April 10, 2026

ADDENDUM NO: 2

Projects: Little Village RAD Modernization and Site Improvements

1 WROUGHT IRON ON BLOCK WALL NS

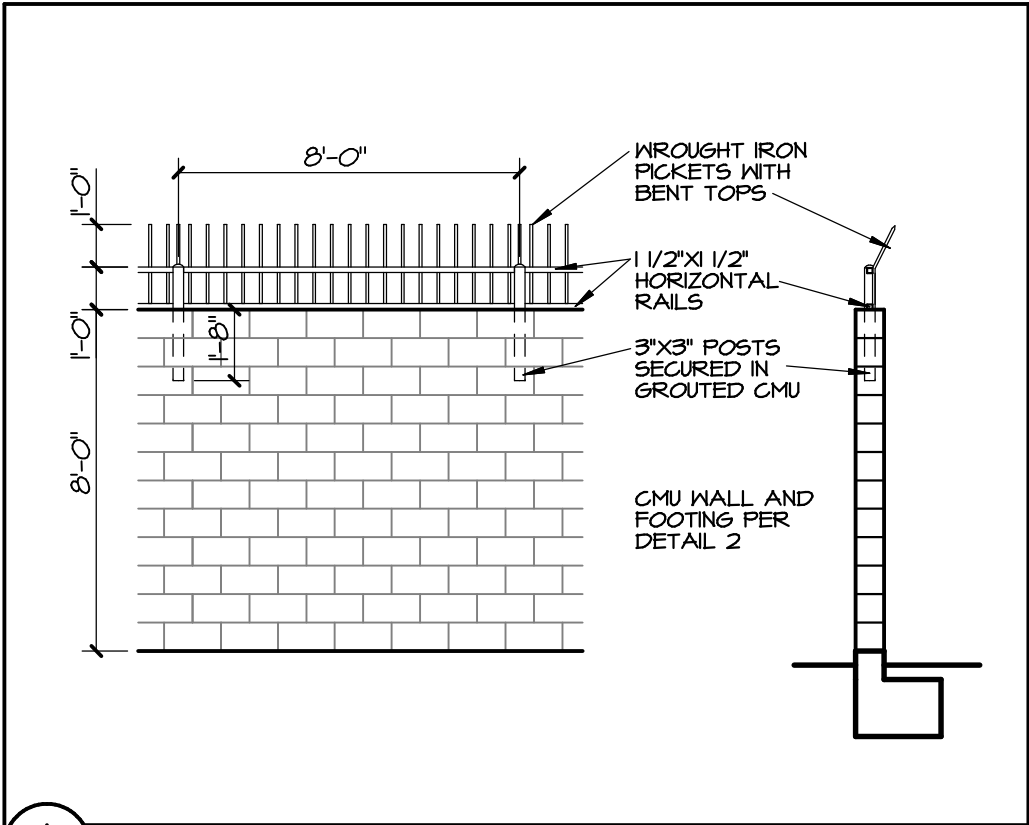
- Item 1: See Addendum No. 1, Site Improvements, Item 11:
Block wall separating project site from railroad tracks shall be per keynote 6. Omit reference to Keynote 20. Details 1 & 2 per attached Diagram 1 of this addendum shall replace details 1 & per Addendum No. 1.

PARTIAL
SITE PLAN - A

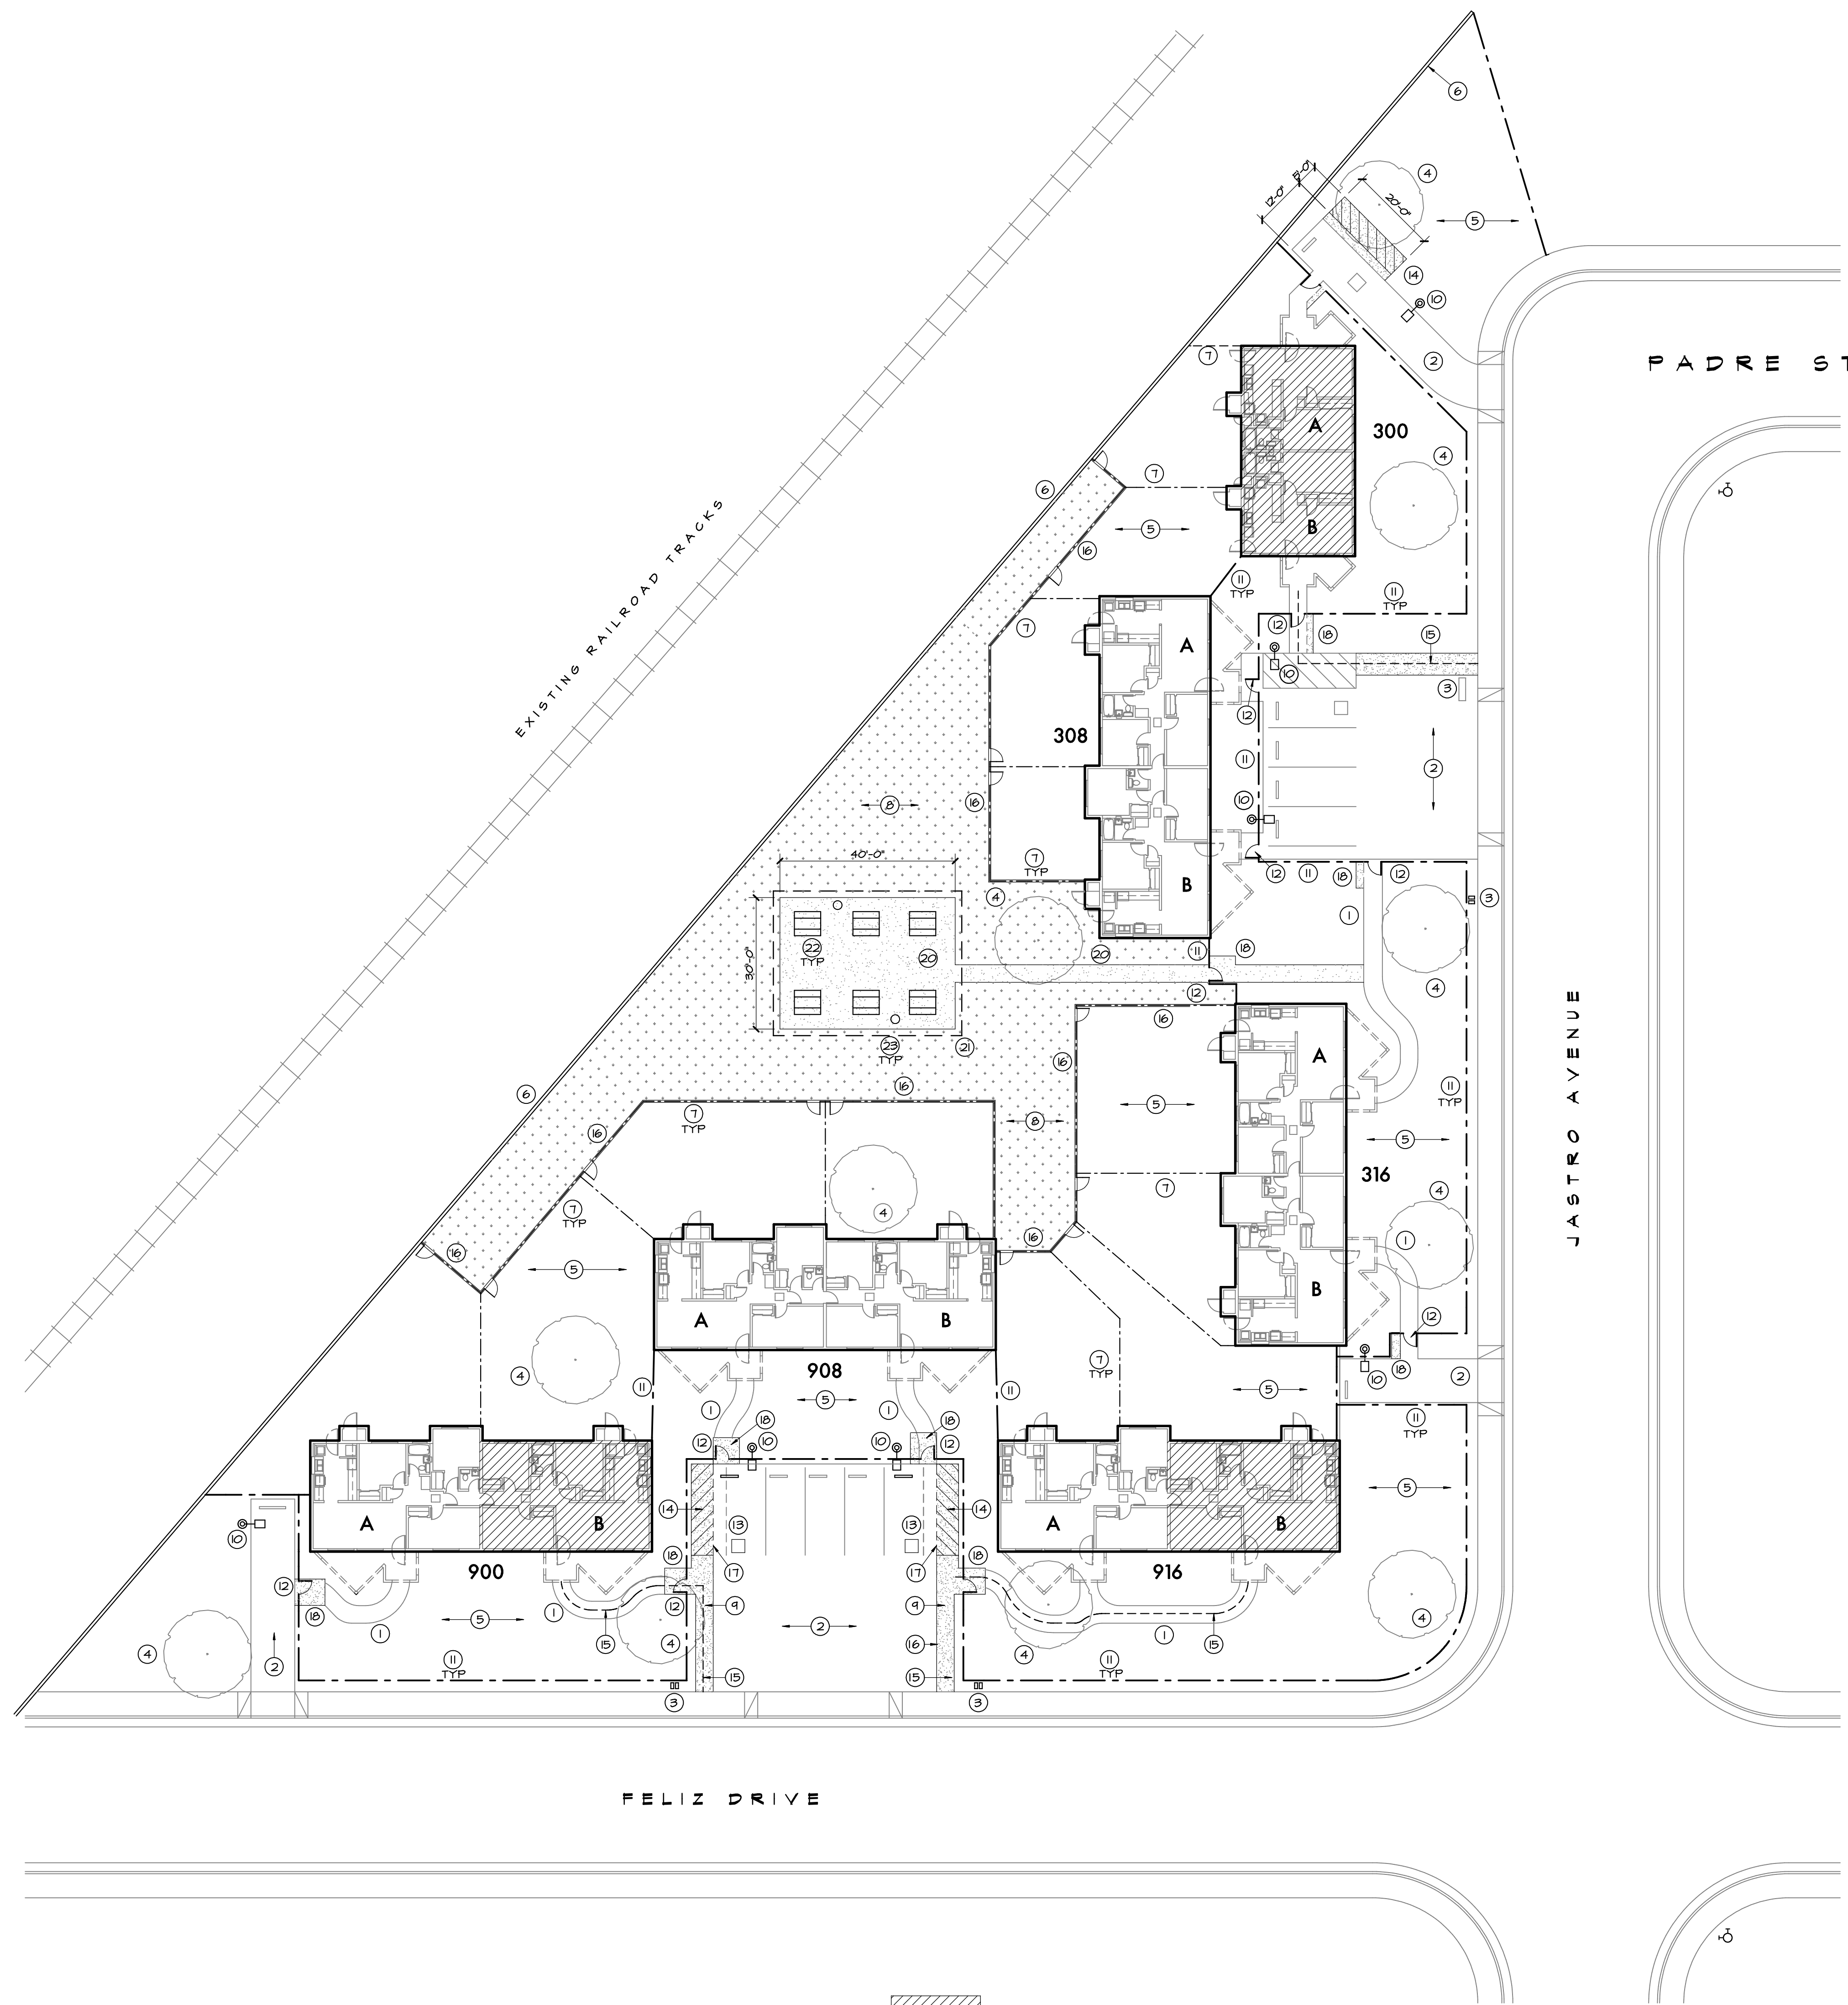
- Item 2: The following specifications shall supersede those listed in Keynote 11 for the new wrought iron fencing: Pickets to be $\frac{3}{4}$ " square x 16 gauge x 94" pre-galvanized spaced at 4.75" o.c. Posts to be 1 $\frac{1}{2}$ " square x 14 gauge pre-galvanized

- Item 3: See Diagram 2 for additional areas of existing grass or natural grade to be replaced with artificial turf per plan specifications and details. New turf area is approximately 23,000 sf. The exact area shall be field verified by contractor.

- Item 4: See attached Diagram 3 for new common area and site improvements in the area west of Jastro Avenue and north of Feliz Drive.
- Item 5: All artificial turf should be bounded by concrete walk, driveway or 6"x6" curb per detail whether graphically shown on plans or not.
